Access Compliance Report

Public Rights-of-Way

Intersection ID: 12826	Main Street: E_5TH_ST	Cross Street: N_ALEXANDER_ST	Location: E
ADA ID: FC070D5421CA	Ramp Type: PerpDiag	Initial Pass/Fail: Fail	Overall Compliance: No
		Severity Score: 60

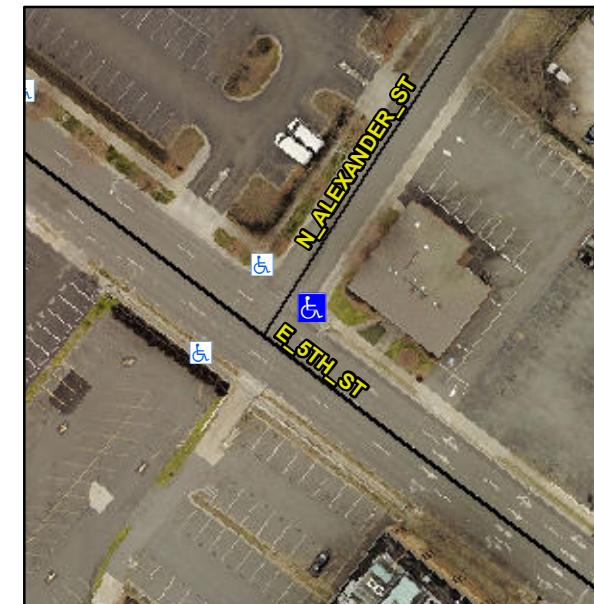
Not Found, R304.5.1, R304.5.3

Compliance	Description	Data	Compliance	Description	Data
N/A	Ramp Length (in)	57.0	Yes	Ramp Slope (%)	7.7
No	Ramp Width (in)	26.0	No	Ramp XSlope (%)	10.3
N/A	Flare Type LT	N/A	N/A	Flare Type RT	N/A
N/A	Flare Slope LT (%)	N/A	N/A	Flare Slope RT (%)	N/A
N/A	Flare Traversable LT?	N/A	N/A	Flare Traversable RT?	N/A
N/A	Landing Length (in)	N/A	N/A	DWS Provided?	N/A
N/A	Landing Width (in)	N/A	N/A	DWS Contrast?	N/A
N/A	Landing Slope (%)	N/A	N/A	DWS Length (in)	N/A
N/A	Landing X Slope (%)	N/A	N/A	DWS Full Width?	N/A
N/A	Landing Curb? (Y/N)	N/A	N/A	DWS Offset (in)	N/A
N/A	Shared Landing?	N/A			
N/A	Gutter Ponding?	N/A	N/A	Gutter Slope (%)	N/A
N/A	Gutter Lip Ht (in)	N/A	N/A	Gutter X Slope (%)	N/A
N/A	Painted X Walk1?	No	N/A	Painted X Walk2?	No
	X Walk 1 Direction	To NW		X Walk 2 Direction	To SW
N/A	X Walk 1 Width (in)	N/A	N/A	X Walk 2 Width (in)	N/A
	X Walk 1 Slope (%)	0.8		X Walk 2 Slope (%)	0.8
	X Walk 1 X Slope (%)	3.8		X Walk 2 X Slope (%)	5.6

Remove & Replace Curb Ramp With Two New Directional Ramps or Equivalent.
